LOUISIANA
POWER & LIGHT

W3P83-2108
Q-3-A29.11

SUBJECT: Waterford SES 3
Docket Number 50-382
Waste Management System

Reference: Letter dated March 28, 1983 from G. W. Knighton to L. V. Maurin

SITE PLAN- LOCATION

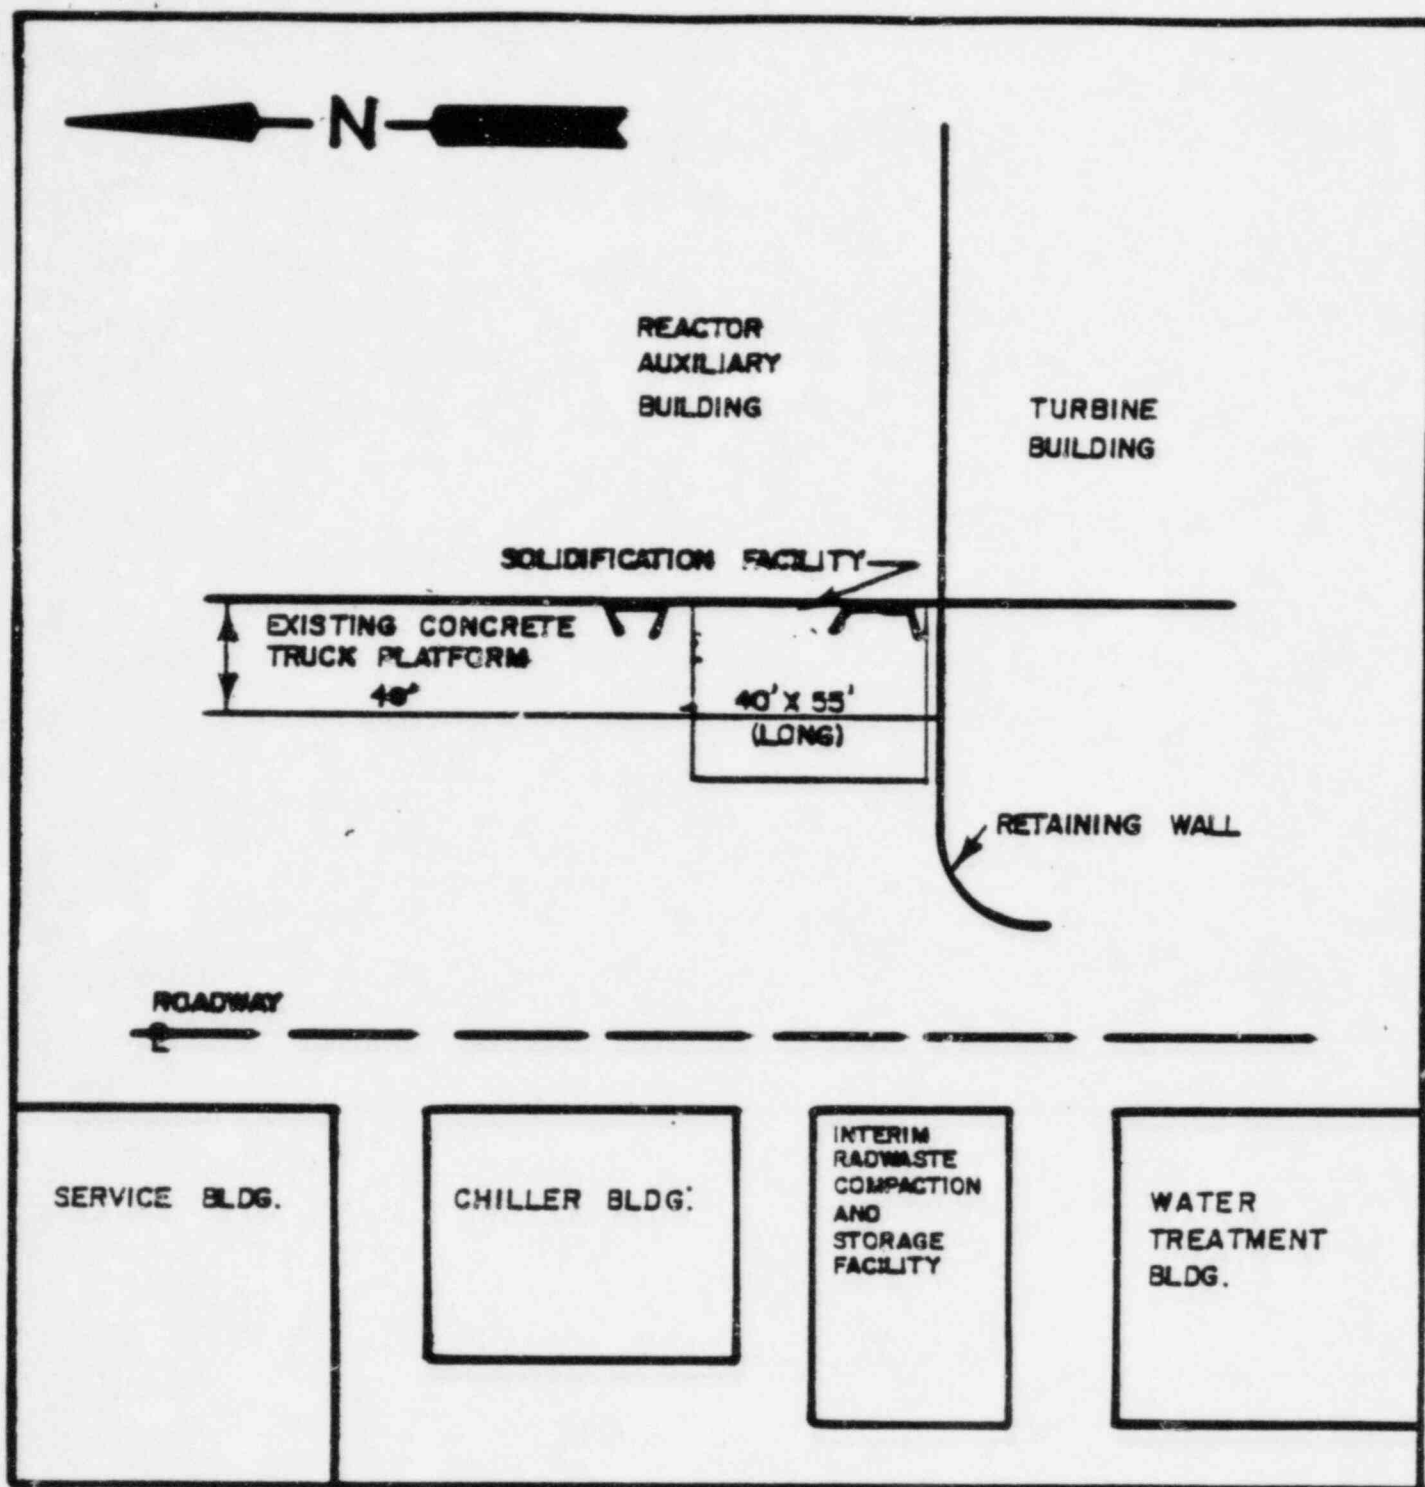
Waterford will utilize a vendor supplied portable solidification system to provide for those plant solidification requirements not satisfied by installed plant equipment. This portable solidification system will be housed in a weatherproof structure with curbing and a sump system which discharges to the LWMS. An overhead bridge crane is provided for lifting requirements up to 10 tons. This structure will be located on the west side of the RAB adjacent to the existing in-plant solidification area (See Figure 11.4-1).

The PSF is a pre-engineered, prefabricated sheet metal building with interior dimensions of ~~7~~^{40'} wide by 55' long with a 30' high eave. The building is located on the concrete truck platform on the west side of the RAB. The area selected for erection of the PSF is between the RAB main access doors and the solidification area doors at elevation +21 ft. (See Figure 11.4-1)

PORTABLE SOLIDIFICATION SYSTEM PLAN VIEW

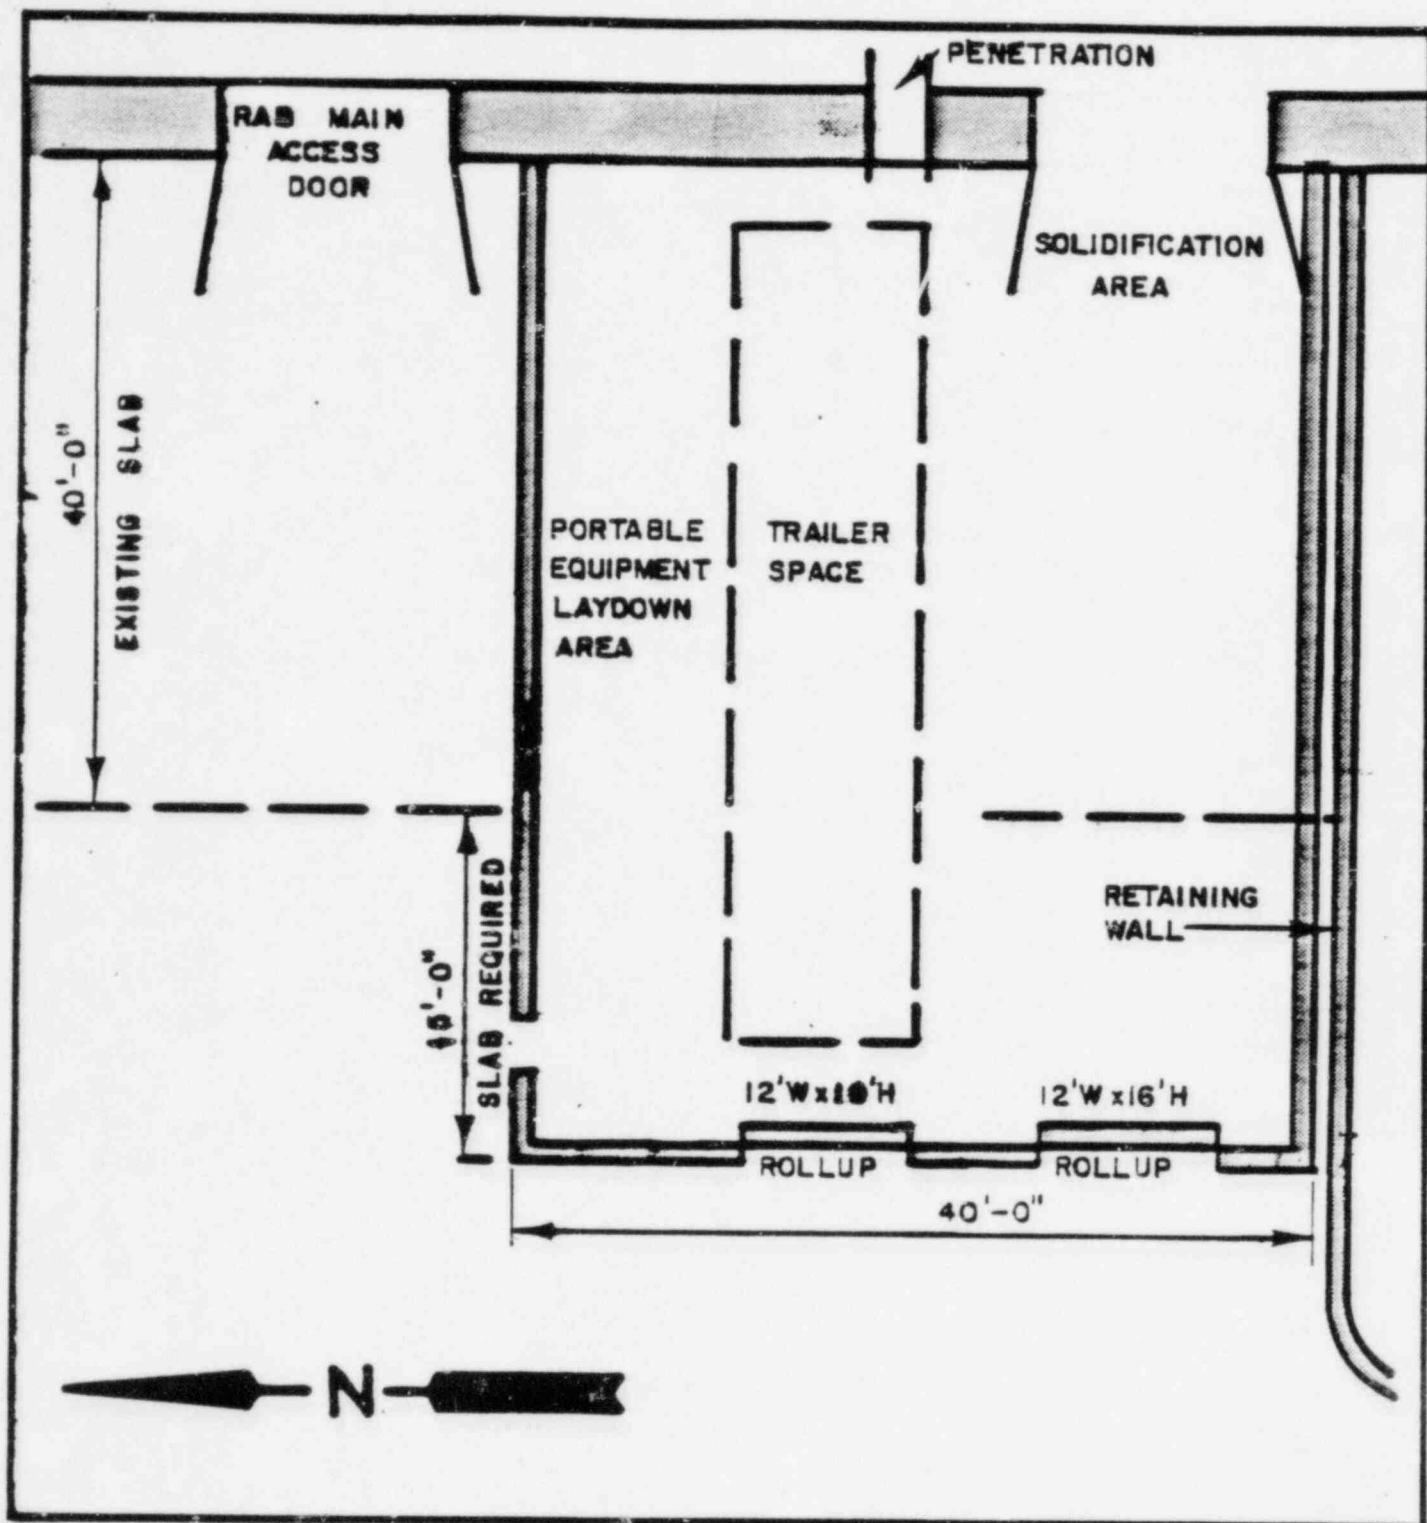
The operation of waste solidification (and/or resin dewatering) will be performed in a shielded waste liner mounted on a trailer. This trailer shall be backed into the PSF and the work performed in this enclosed building. Waste is supplied to the liner by flexible hoses connected to waste transfer lines routed from inside the RAB out to the PSF. Support equipment for the portable system is mounted on skids. The PSF will supply space for the trailer, the skid mounted equipment, and materials required by the contractor for solidification. (See Figure 11.4-2)

INTERIM RADWASTE COMPACTION AND
STORAGE FACILITY PLAN VIEW

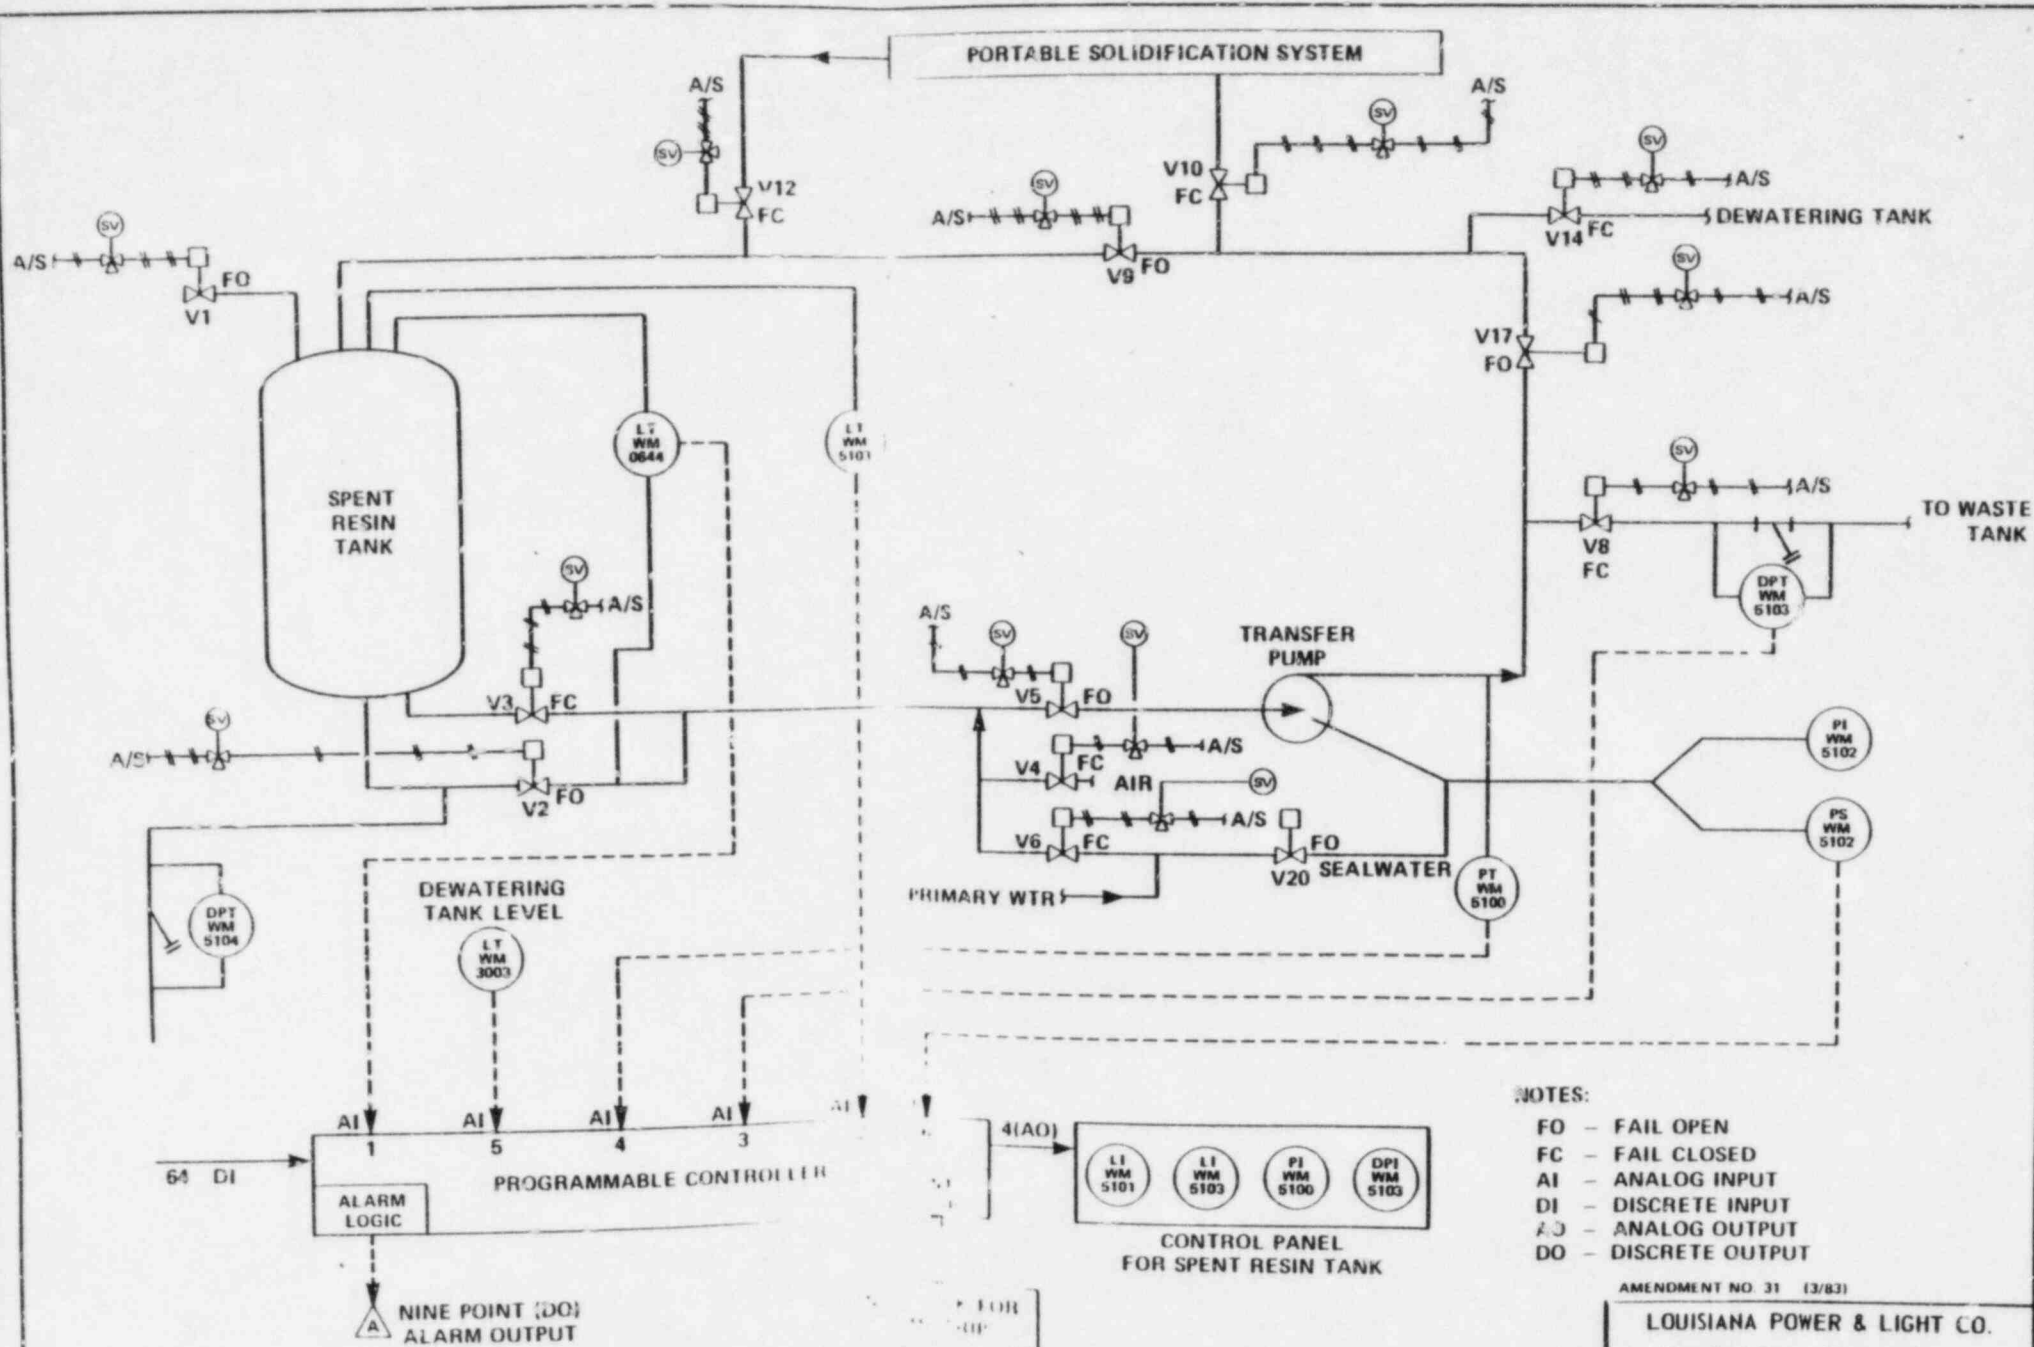
The building is 55' by 40' and has sufficient storage capacity to house 76 6' x 4' x 4' metal boxes of compacted waste. The boxes are handled with a forklift. (See Figure 11.4-4).

Space has also been provided in the facility to temporarily store contaminated laundry. This area is 8' x 22' and walled separately from the waste compaction activities.
